Title - Sujet Mechanical & Electrical Sys Upgrade	
Solicitation No. - N° de l'invitation EZ899-161426/A	Amendment No. - N° modif. 008
Client Reference No. - N° de référence du client	Date 2015-12-11
GETS Reference No. - N° de référence de SEAG PW-\$PWY-032-7656	
File No. - N° de dossier PWY-5-38257 (032)	CCC No./N° CCC - FMS No./N° VME
Solicitation Closes - L'invitation prend fin at - à 02:00 PM on - le 2015-12-17	Time Zone Fuseau horaire Pacific Standard Time PST
F.O.B. - F.A.B. Plant-Usine: <input type="checkbox"/> Destination: <input checked="" type="checkbox"/> Other-Autre: <input type="checkbox"/>	
Address Enquiries to: - Adresser toutes questions à: Large, Kathy(pwy)	Buyer Id - Id de l'acheteur pwy032
Telephone No. - N° de téléphone (604) 666-2891 ()	FAX No. - N° de FAX (604) 775-6633
Destination - of Goods, Services, and Construction: Destination - des biens, services et construction: AAFC - Pacific Agri-Food Research Centre - Summerland, BC

This Addendum 003 is raised to incorporate the BidCentral Online Bidding for Subcontractors (BOBS) Pre-Bid Interpretations 4 and 5 and to respond to questions from bidders.

PRE-BID INTERPRETATION No. 4

PRE-BID INTERPRETATION No. 5

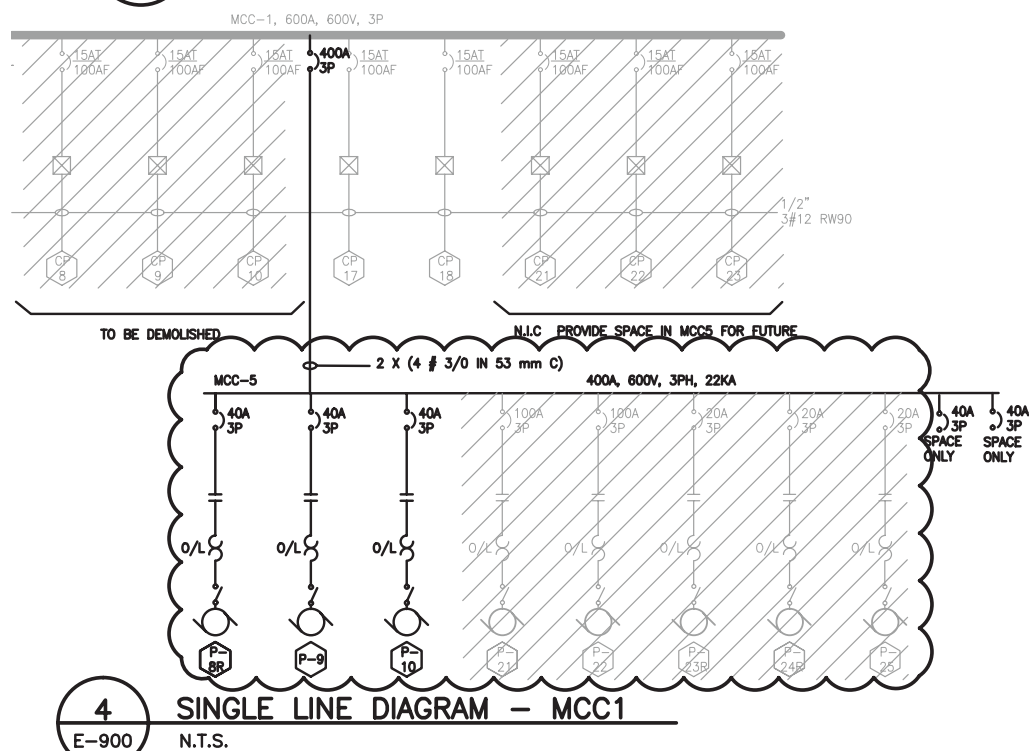
- .1 E-900
 - .1 Revise E-900 detail 3 and detail 4, see enclosed ESK-02.

- .1 Q2: Are we to supplying MCC 5 & MCC 5S
A2: Yes, MCC 5 and MCC 5s are new electrical equipment as identified on Drawings E-150 and E-900.
- .2 Q3: Are we supplying the breakers for these MCC's
A3: Yes, refer to enclosed ESK-02.
- .3 Q4: If we're are supplying MCC's ,please clarify number of ccts required
A4: Refer to enclosed ESK-02.
- .4 Q5: Are we supplying new feeders from MDC-SN to MCC 5S
A5: Refer to enclosed ESK-02.
- .5 Q6: Are we supplying new feeders and breaker from MCC 1 to MCC 5?
A6: Refer to enclosed ESK-02.
